Mandatory Service Bulletin

Mandatory update to DMC firmware V11R3b5 and mounting of revised resistive arrestor strap necessary

- This document contains information about updating the DMC Firmware V11R3b5 and protecting the DMC board against damages.
- It also provides information for the mounting of the resistive arrestor strap.

Figure 2

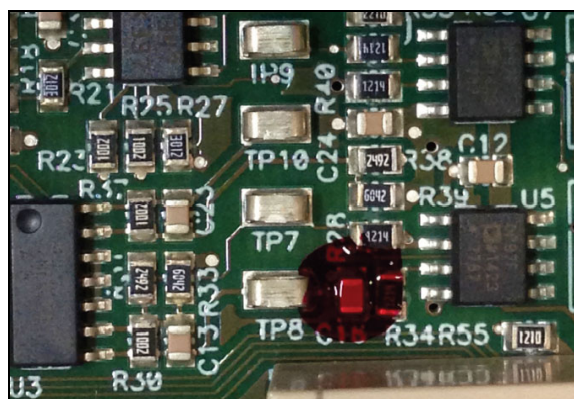
- After the replacement it is necessary to protect the DMC board SAT-A3539-01 against possible damages (e.g. during the measurement of the voltage on the Test Point TP8). For that it is necessary to apply a coating protection over the C16 capacitor before measuring the voltage. Use Loctite 7400 for coating.
- In case the Loctite 7400 is not available use a piece of electrical tape over the C16 capacitor. In case the tape is used it should be removed after adjusting the TP8 voltage.

Figure 3

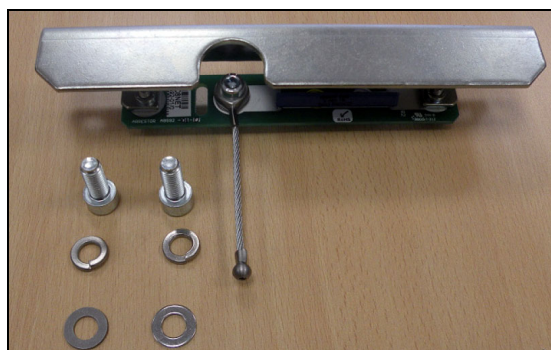
SC+A9365-01 Resistive arrestor kit

Solution Replace the old arrestor strap with the revised arrestor.

Figure 6 - Bottom view of the mobile unit

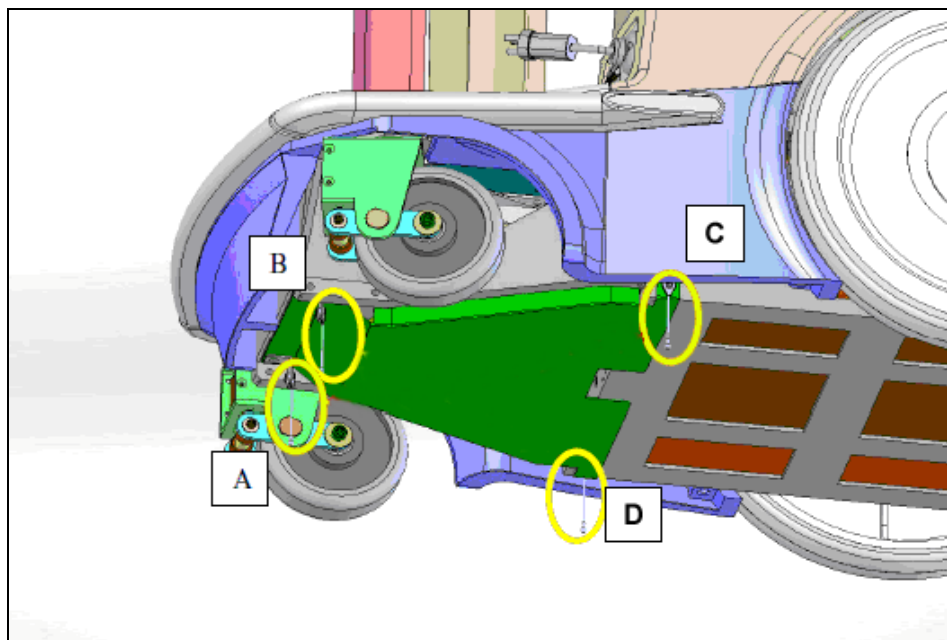
- If no arrestor is mounted: 15 minutes
- If arrestors are mounted at position A or B: 15 minutes (see figure 6)
- If arrestors are mounted at position C or D: 120 minutes (see figure 6)

- (3) Check if an arrestor is directly fixed to the frame (see figures below for possible locations).
- (4) Only required if an arrestor is mounted at position C or D:
Remove the covers of the DX-D 100 / DX-D 100 wireless as explained in the troubleshooting chapter of the service manual.

Figure 9

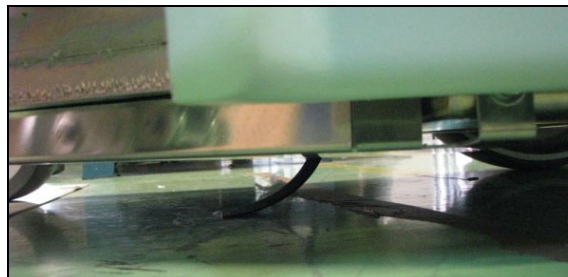
- (5) In case that an arrestor is present: Remove the old arrestor from the unit.

If one of the arrestors is a rubber arrestor:
Cut the rubber.

Figure 10 - Location of the column cable protector cover

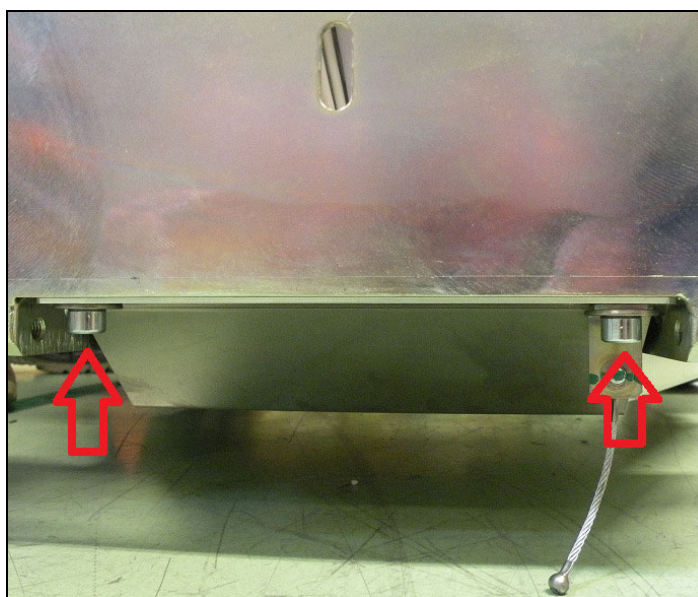
- (6) Remove both screws shown in the figure below.
See also figure 4: The screws are located at position A and B.

Figure 11 - Column cable protector cover without screws

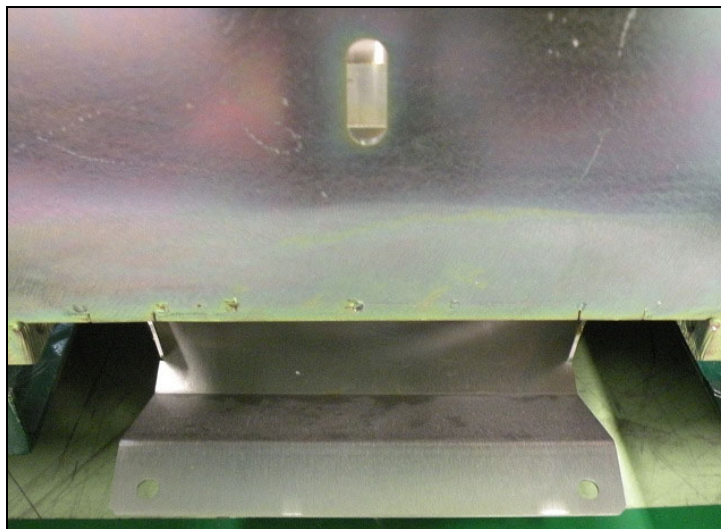
- (7) After removing both screws, the column cable protector cover will go to down position as shown in the figure below.

Figure 13 -
Locations of the resistive arrestor assembly
fixing screws

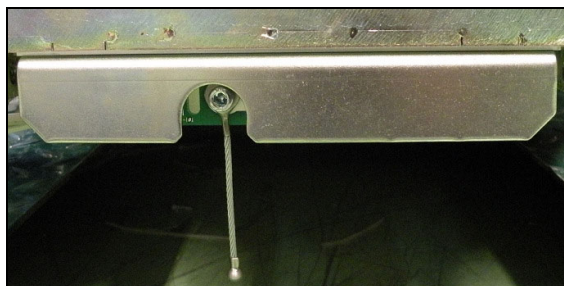
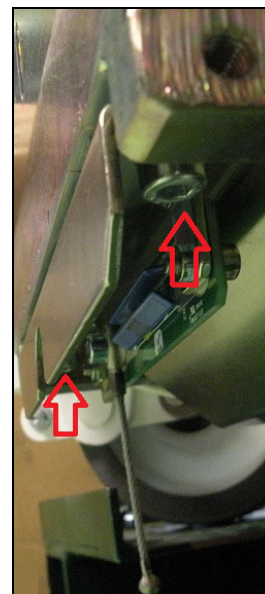
- (8) Lift the column cable protector cover to the original position. Install the resistive arrestor assembly with the screws and the washers included in the kit as shown in the figures below.
